Access Compliance Report Public Rights-of-Way (Curb Ramps)

Main Street: SIENNA_PKWY Cross Street: SECOND_ST Location: NE

ADA ID: RPRK211108112914 Ramp Type: Type 4 - Parallel Initial Pass/Fail: Pass Overall Compliance: No Severity Score: 10

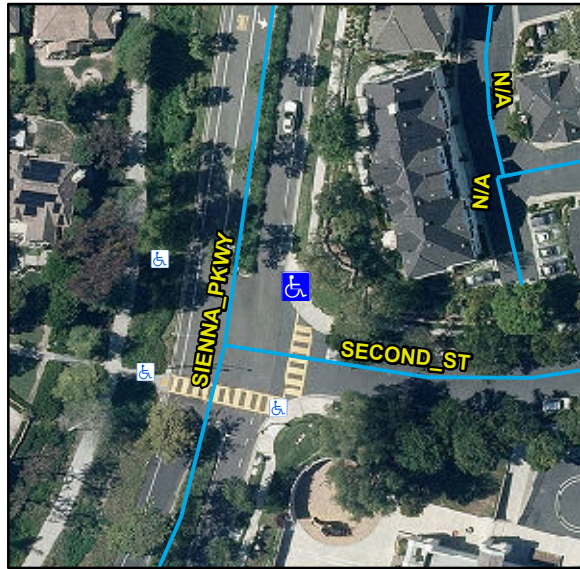
Compliance	Description	Data	Compliance	Description	Data
N/A	Ramp Length LT (in)	89	N/A	Ramp Length RT (in)	68
Yes	Ramp Width LT (in)	86	Yes	Ramp Width RT (in)	86
Yes	Ramp Run Slope LT (%)	7.1	Yes	Ramp Run Slope RT (%)	1
Yes	Ramp Cross Slope LT (%)	0.4	Yes	Ramp Cross Slope RT (%)	0.6
N/A	Landing Present	No	Yes	DWS Provided	Yes
N/A	Landing Length (in)	N/A	Yes	DWS Contrast	Yes
No	Landing Width (in)	N/A	Yes	DWS Length (in)	36
No	Landing Run Slope (%)	N/A	Yes	DWS Full Width	Yes
No	Landing Cross Slope (%)	N/A		DWS Offset Type	Single
N/A	Landing Movement Obstructed?	No	Yes	DWS Offset Left (in)	0
	Landing Movement Type	Curb	Yes	DWS Offset Right (in)	N/A
N/A	Landing Shared	N/A			
N/A	Clear Space	Yes			
N/A	Clear Space To Crosswalk (in)	48			
N/A	Marked Crosswalk 1	No	N/A	Marked Crosswalk 2	Yes
	Crossing 1 Direction	NW		Crossing 2 Direction	SW
	Marked Crosswalk 1 Width (in)	N/A		Marked Crosswalk 2 Width (in)	120
N/A	Ramp Inside Crosswalk 1	N/A	Yes	Ramp Inside Crosswalk 2	Yes

Crossing 1 Slope (%)	1.2		Crossing 2 Slope (%)	0.5
	Crossing 1 Cross Slope (%)	4.1		Crossing 2 Cross Slope (%)	3.3
Yes	Gutter Ponding	No	Yes	Curb Slope	3.4
Yes	Gutter Lip Height (in)	0		Road Run Slope (%)	3
Yes	Gutter Run Slope (%)	2.9		Road Cross Slope (%)	0.8
No	Gutter Cross Slope (%)	2.2	Yes	Perpendicular Joint Present	Yes
Yes	Overall Surface Condition	Acceptable			
	Cross Gutter Present?	No		Spandrel Present?	No
	Replace Cross Gutter?	N/A		Replace Spandrel?	N/A

Install Landing. Remove & Replace Gutter.

R304.2.1, R304.2.2-Perp, R304.3.2-Para, R304.5.3, STD 1115
